<b>JRPP Number</b>	<b>2011SYW087</b>
<b>Application Number</b>	<b>DA-1210/2011</b>
<b>Proposed Development</b>	<b>Demolition of existing structures and construction of a residential flat building comprising fifty-three (53) residential units and two levels of basement car parking with vehicular access to be provided from Campbell Street and associated landscaping and service features.</b>
<b>Property Description</b>	<b>Part Lot 1 DP 1053951, Part Lot 2 1053951 93-95 Campbell Street Liverpool NSW 2170</b>
<b>Applicant</b>	<b>Gelder Architects</b>
<b>Land Owner</b>	<b>Talbus Pty Ltd</b>
<b>Capital Investment Value</b>	<b>\$11,000,000</b>
<b>Recommendation</b>	<b>Refusal</b>

**7.3 Design Review Panel (DRP) Assessment****LIVERPOOL CITY COUNCIL  
DESIGN REVIEW PANEL ASSESSMENT REPORT**

**Re: 93 + 95 Campbell Street Liverpool**

### Site Plan

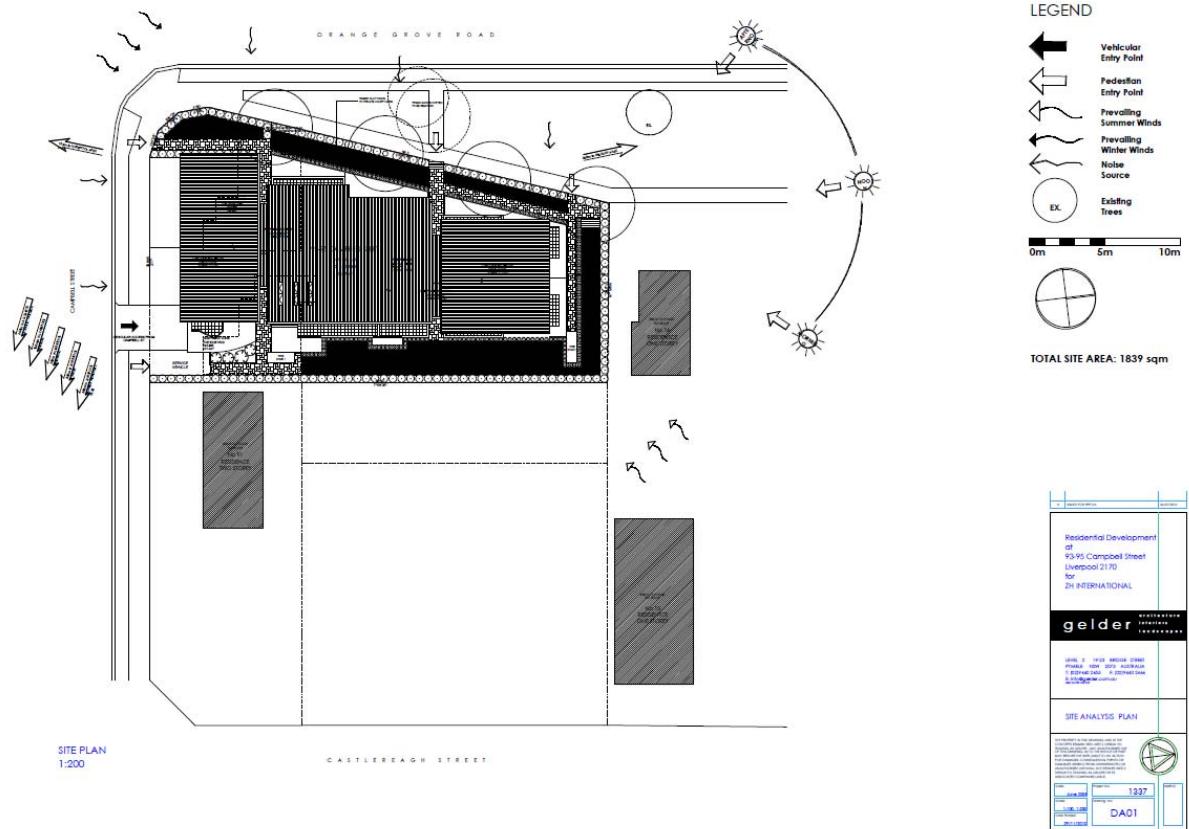
*Note that the north western fire stair enclosure has not been drawn correctly, and would in fact be twice the width depicted in order to accommodate the return stair-flight.*

- The main communal open space is elevated up to 1m above ground level on the adjoining residential properties, raising concerns in relation to privacy and general amenity of those neighbouring properties (at present or in relation to future development for the vacant neighbouring property to the east).

*Note that basement design does not demand the elevation of this communal area, and concerns would be resolved by lowering the open space.*

### Elevation Plans

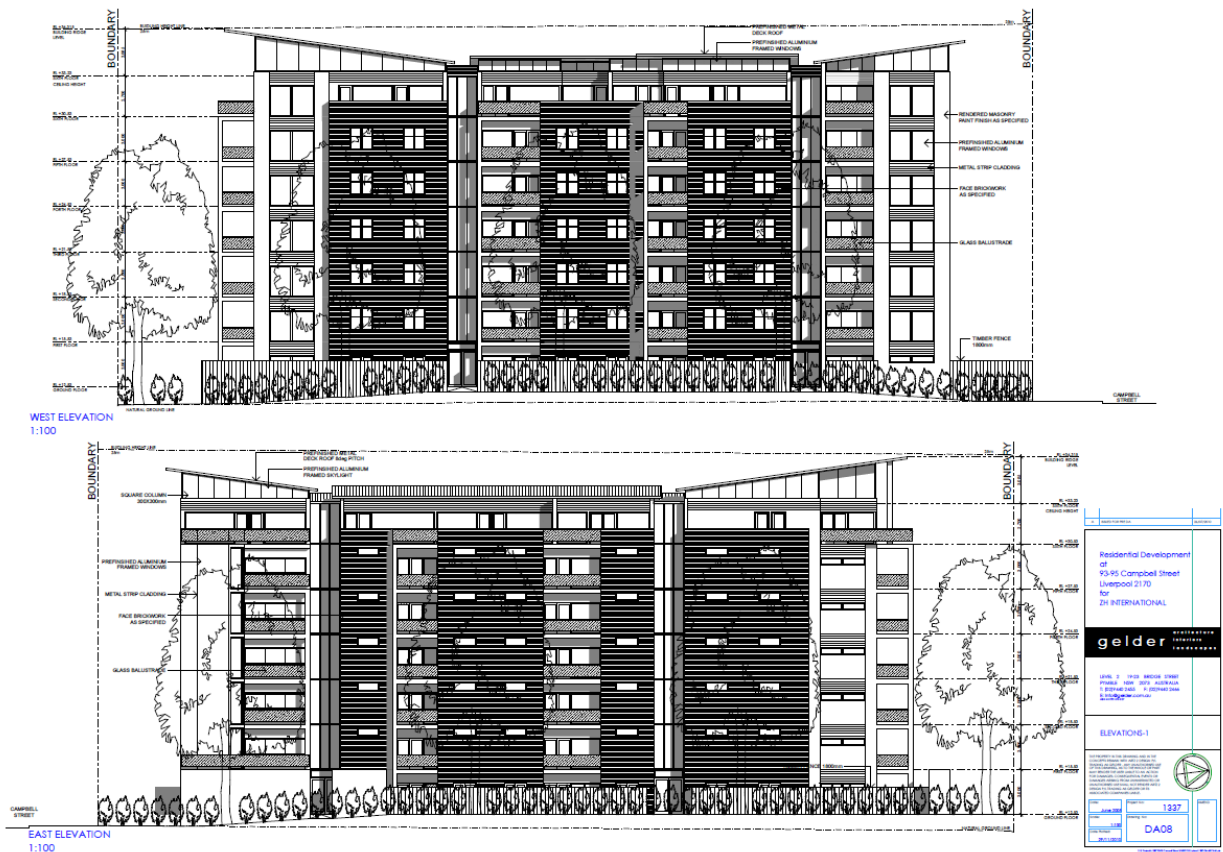
Overall, treatment of facades displays no evidence of a consistent or coherent design logic where form, proportions and elements provide comprehensive responses to environmental factors such as westerly sun and road noise, or social factors such as privacy and utility of outdoor rooms (ie balconies). Treatment of facades has not mitigated the scale of sheer vertical walls, or provided effective "horizontal articulation" of the proposed building form.
